CRESTVIEW SUBDIVISION DEVELOPMENT

Lane Council of Governments

Lowell Planning Commission Public Hearing

Planning Commission
Public Hearing: April 14, 2020

Attachment M

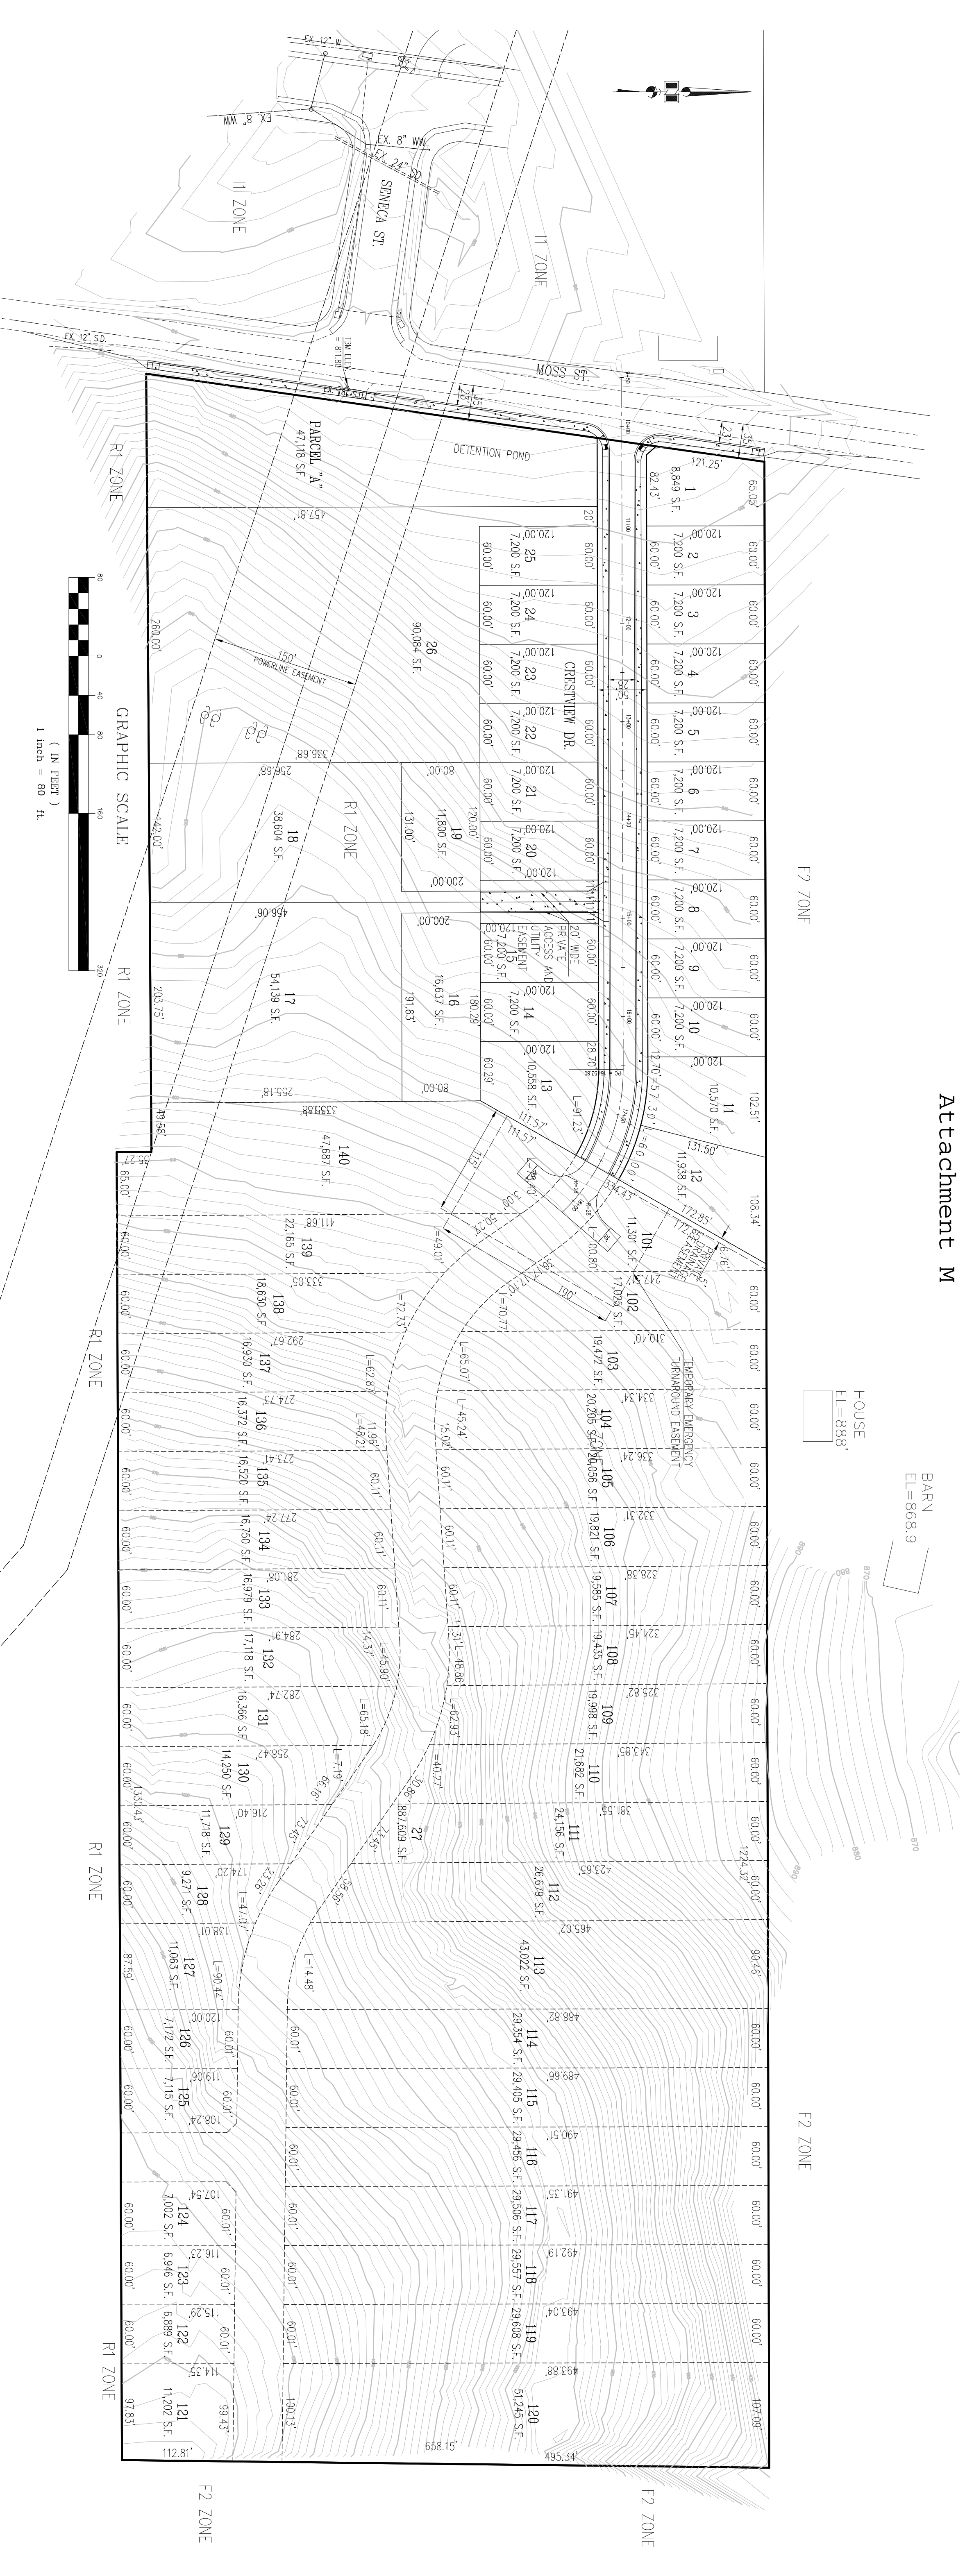
Discussion: The proposed property division will result in four lots (lots 17, 18, 26, 27), that are larger than 2.5 times the minimum lot size. The applicant did provide a shadow plat, as seen on Sheet 5 (**Attachment M**), to show how Lot 27 could be further subdivided in the future. Further division on lots 17, 18 and 26 are not practicable due to a 150-foot BPA easement that runs through the lots and access is already an issue with the applicant requesting a variance to allow four lots to utilize the same access point.

Recommended FINDING for approval: As shown on Sheet 5, the applicant has provided a shadow plat showing how lot 27 could be further subdivided. As discussed above, further residential development on lots 17,18 and 26 are not expected nor practical for the reasons mentioned above. Criterion met.

LANE COUNTY
DEPARTMENT OF PUBLIC WORKS
ENGINEERING DIVISION

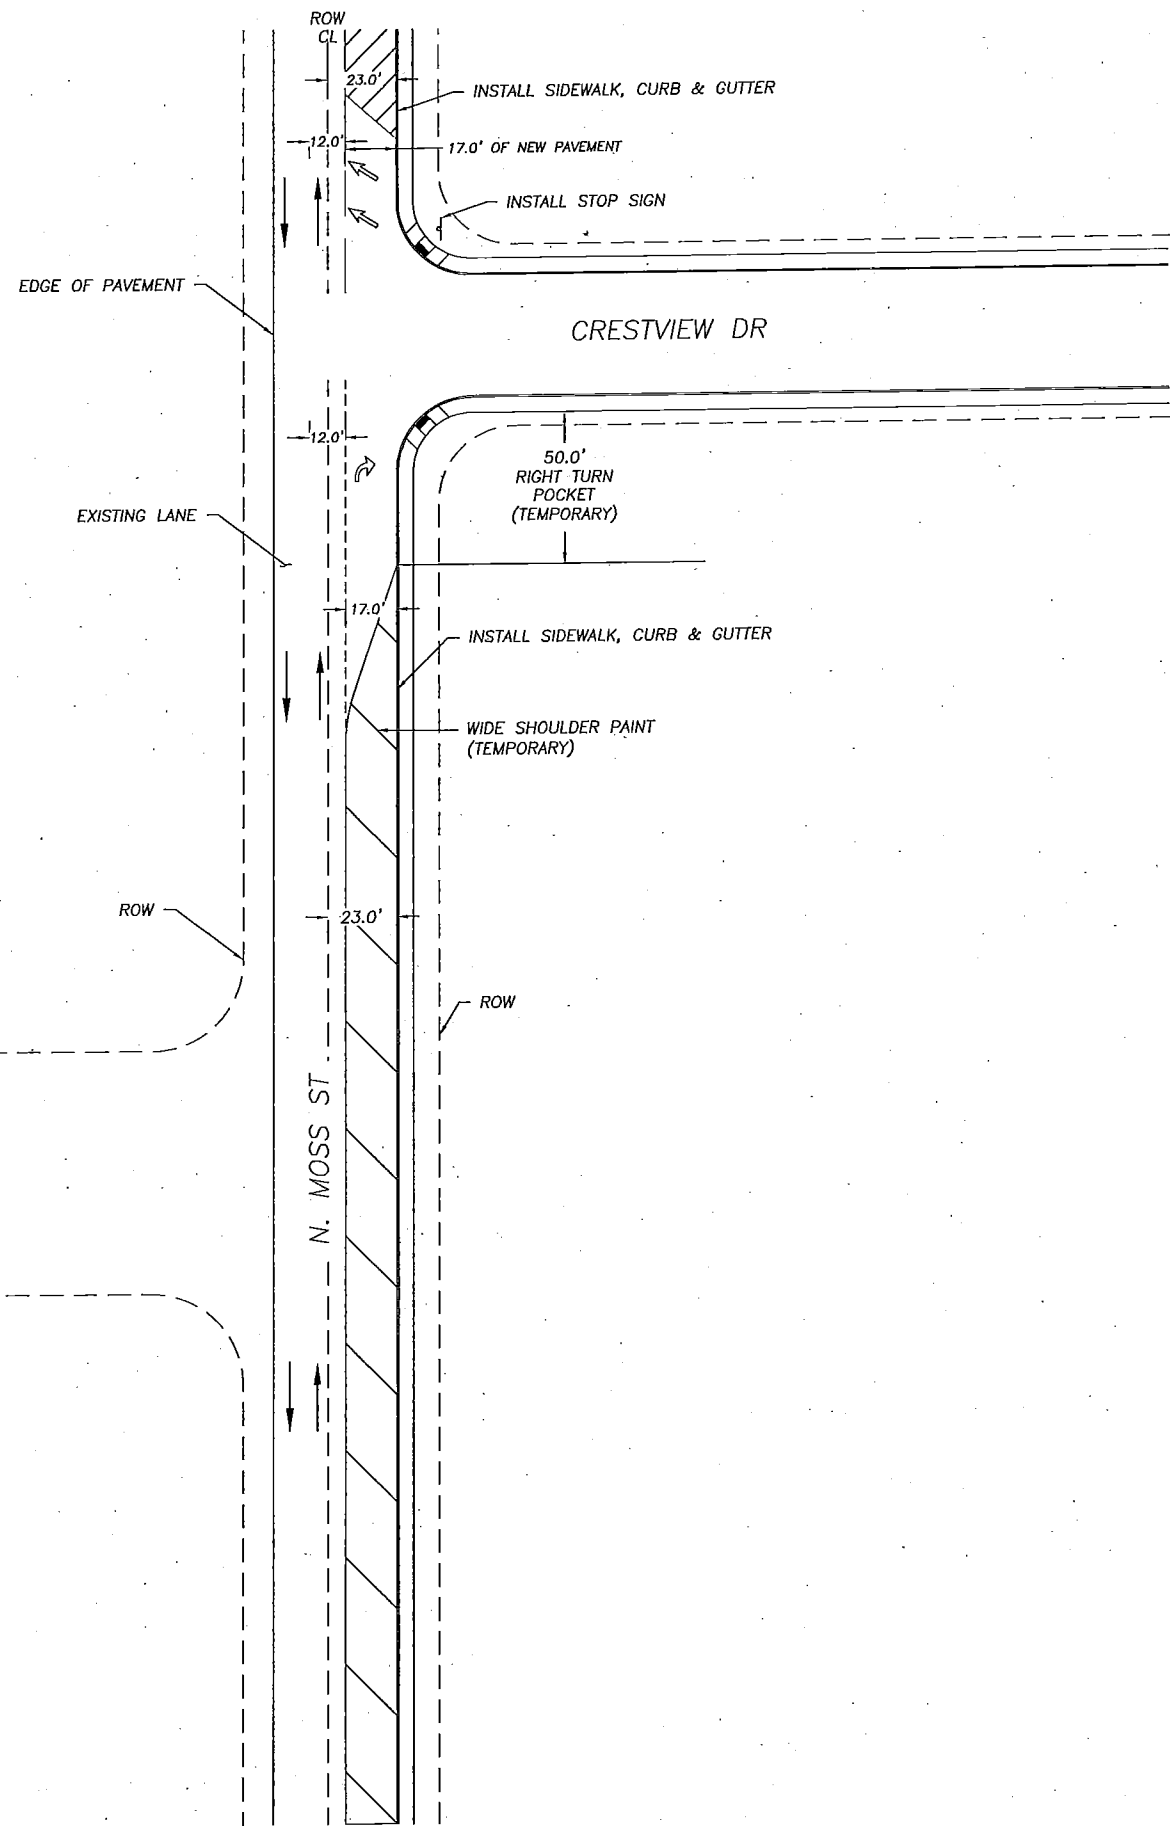
The County first asked us for 23' from centerline. Now it looks like 20' with the right turn lane. The sketch makes no sense! I need a distance from centerline RW to curb face. Brad Lemhouse should be in on this too.

- NOTES**
1. REQUIRE 23' IMPROVEMENTS AS SHOWN ON LANE CODE TYPICAL SECTION.
 2. DO NOT CREATE CENTER LANE OR BIKE LANE UNTIL FUTURE DEVELOPMENT IS COMPLETED.
 3. CREATE A TEMPORARY RIGHT TURN LANE AS SHOWN.
